802.1Qay D3.0: State Machine Instances

State Machine Instances

State Machines for Load Sharing Mode

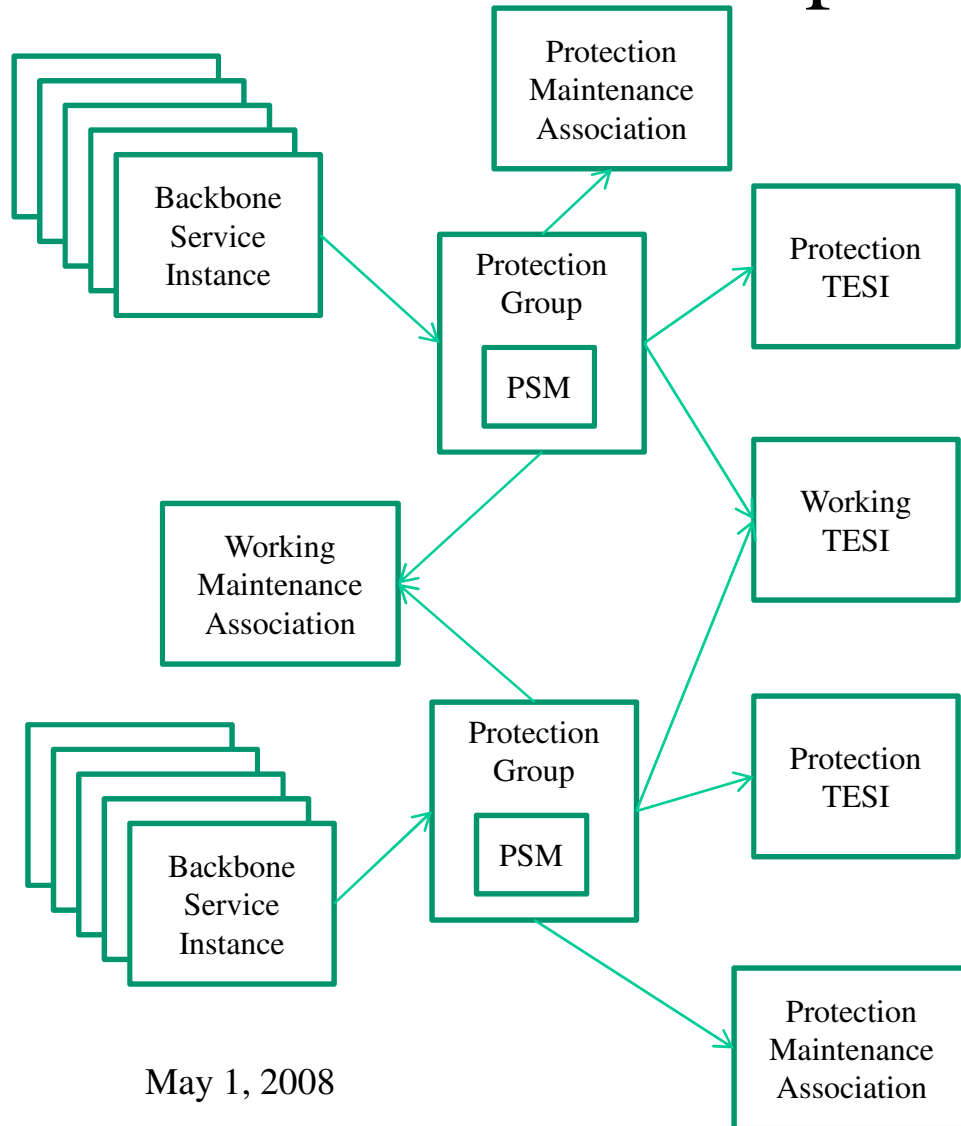
Concerns with the current model

- 2 completely separate behaviors depending on the mode.
- The current Path state machine is very similar to the Protection state machine. This does not make sense since they are serving different purposes.
 - Protection: switching between TESI
 - Path: can the TESI carry traffic
- Load sharing multiplies the number of active state machines. This is a concern for scalability especially since there is a state machine per BSI.

Alternative: allow TESIIs to be used by more than 1 protection group...

- Each protection group has several associations:
 - 1 Working TESI
 - 1 Protection TESI
 - 1 Working MA
 - 1 Protection MA
- These protection groups are sharing a working tunnel and have separate protection TESIIs
- The protection TESIIs can be used for other protections groups as working TESIIs

Advantages

- The state machines used in each mode is identical
- The provisioning of each mode is identical
- Scalability is improved since there is only a state machine per protection group.
